# Technical Service Information

## THM 4L80E/4L80EHD

### NEW DESIGN OVERRUN ROLLER CLUTCH

**CHANGE:** Beginning in March 2001, a new design Overrun Roller Clutch was introduced into the THM 4L80E, as a running change. This engineering change affected many other related parts.

Figure 1

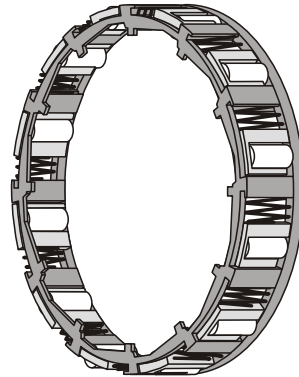
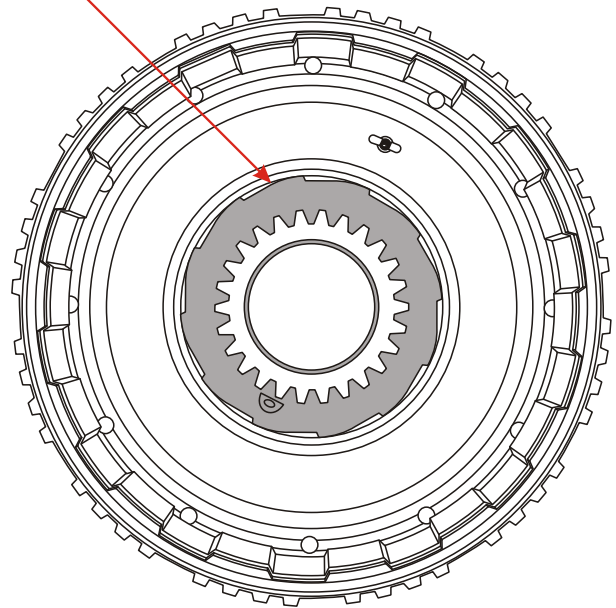
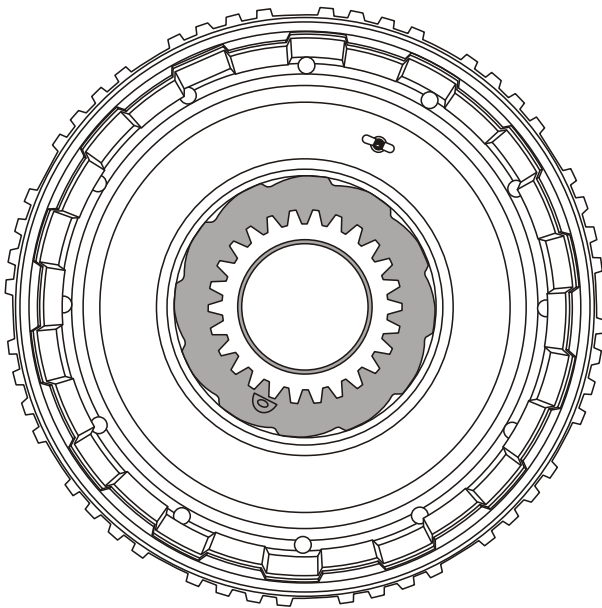
- (1) OVERRUN ROLLER CLUTCH - Entirely new design with smaller diameter rollers and the rollers are now trapped inside of a "Shoe" to help prevent skewing, and the springs put pressure on the "Shoe", as shown in Figure 1.

- (2) OVERRUN CLUTCH HOUSING - Requires a different ramp angle on the inner cam, to accommodate the new design roller clutch, as shown in Figure 1. The snap ring was also moved away from the back of the roller clutch which required a new snap ring groove that is lower in the housing, as shown in Figure 2.

Figure 2

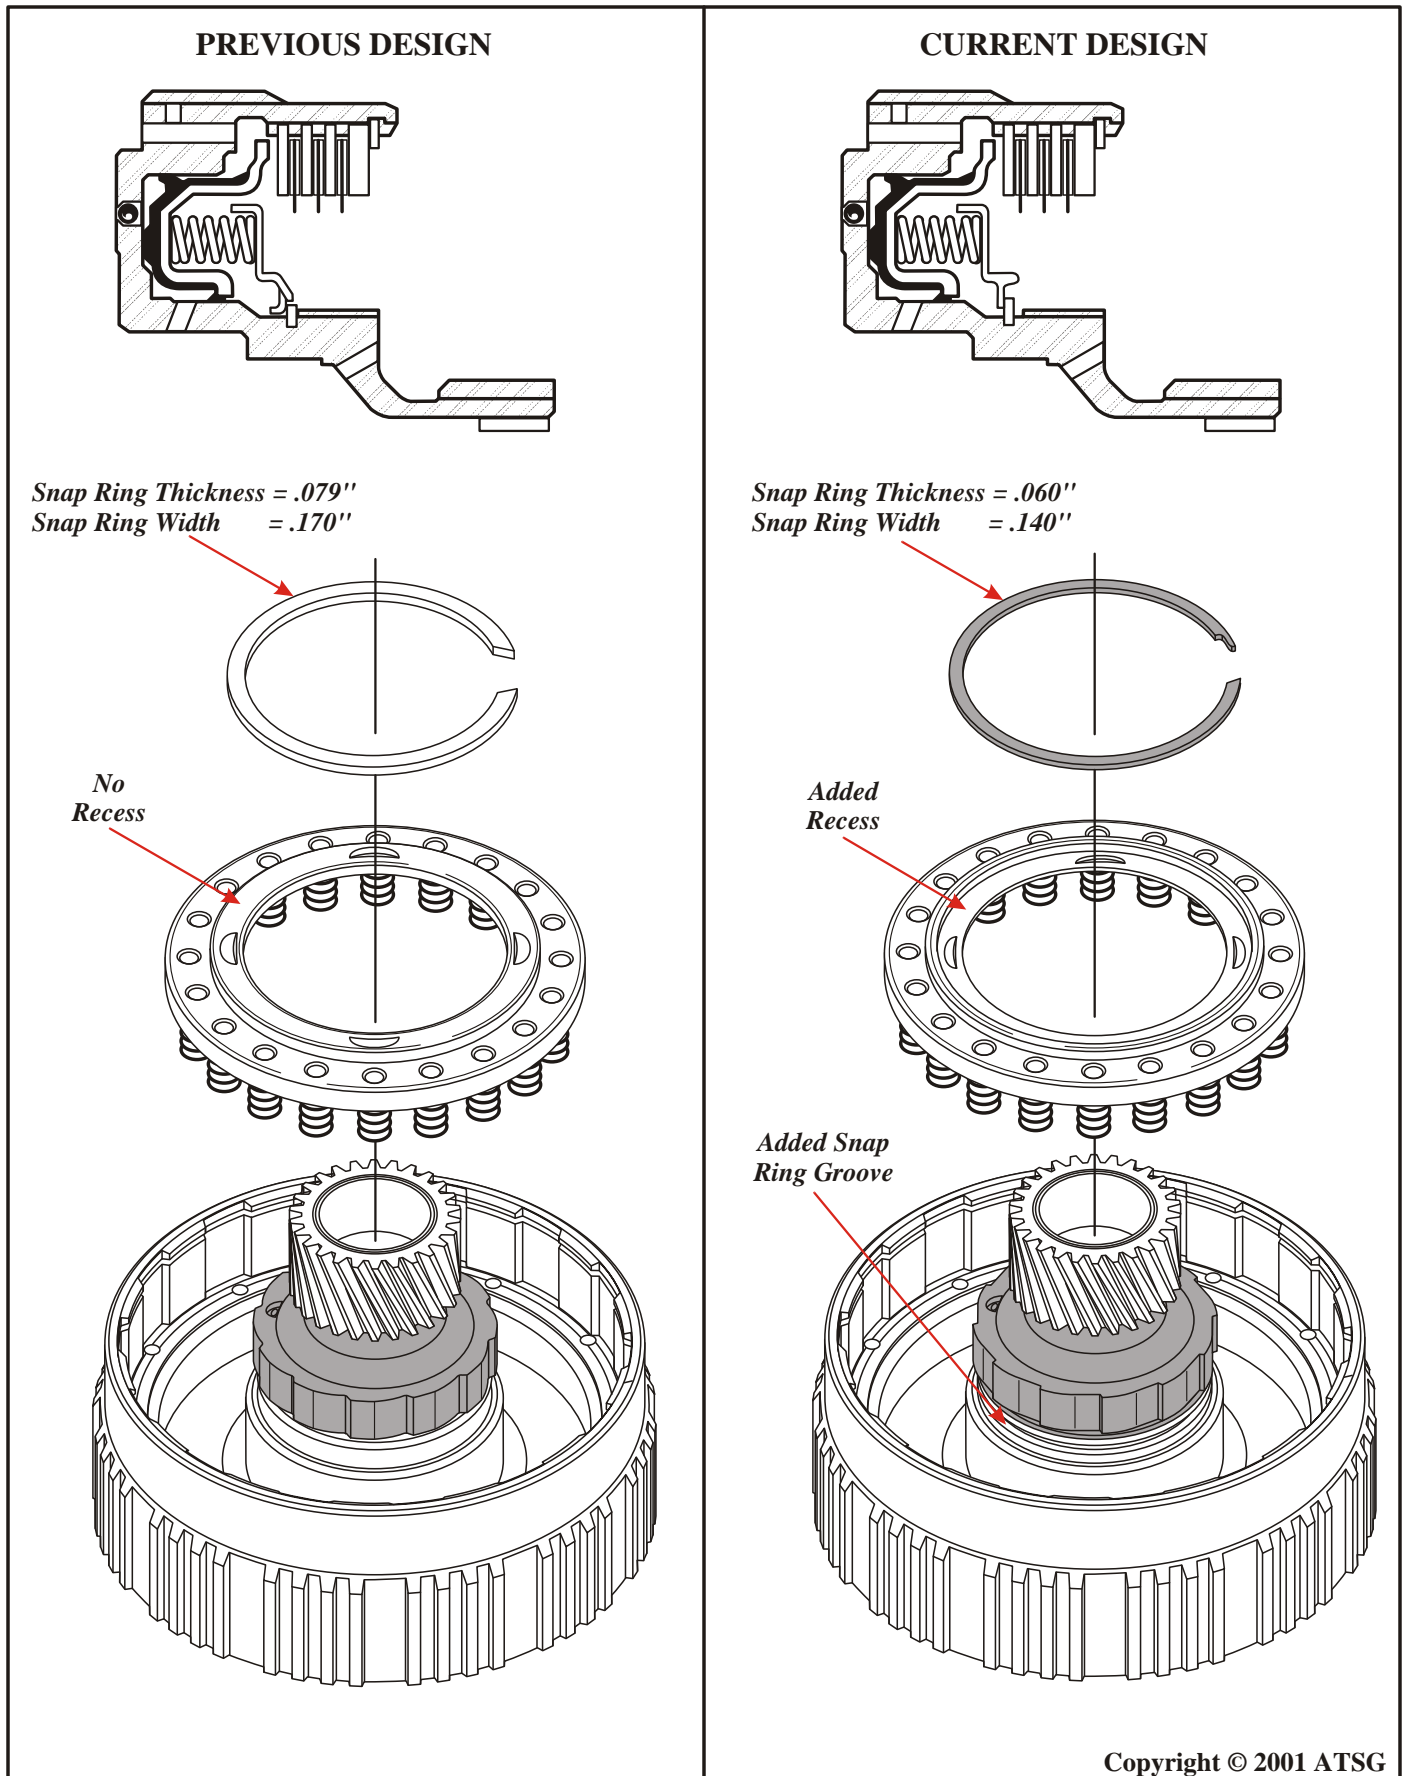
- (3) OVERRUN ROLLER CLUTCH RETURN SPRING - Now requires a recess in the return spring retainer to accomodate the relocated snap ring groove, as shown in Figure 2.

- (4) RETAINER SNAP RING - New design has revised dimensions, as shown in Figure 2. The new design snap ring is thinner and narrower.
- (5) OVERDRIVE PLANETARY CARRIER - The new design has a smaller diameter roller clutch outer race incorporated in the overdrive carrier, as shown in Figure 3.

Figure 4

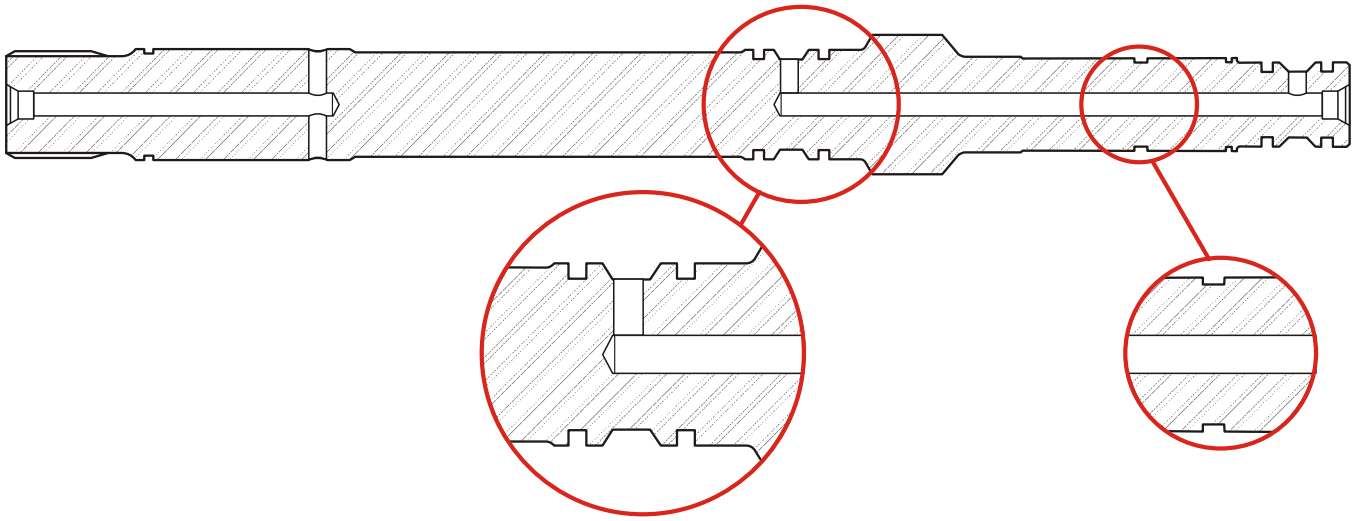
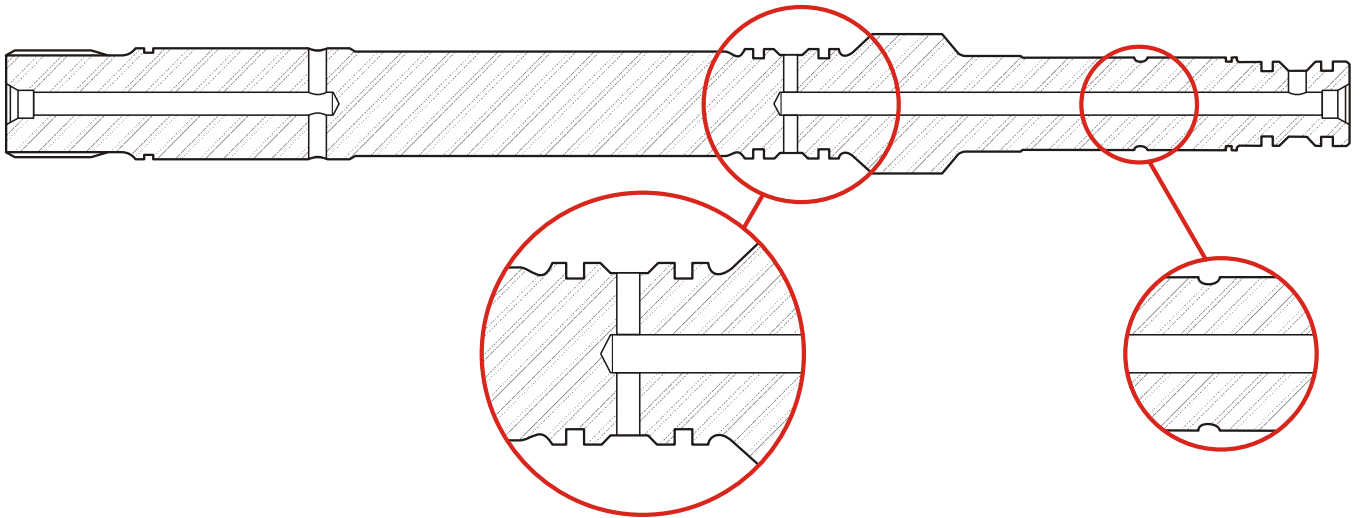
*If installing this service package into an early model, with the 1st design turbine shaft, you must also purchase the 2nd design turbine shaft, as shown in Figure 4. The changes included shot peening the area around the forward clutch feed hole, the feed hole diameter reduced and drilled through the turbine shaft (See Figure 4).*
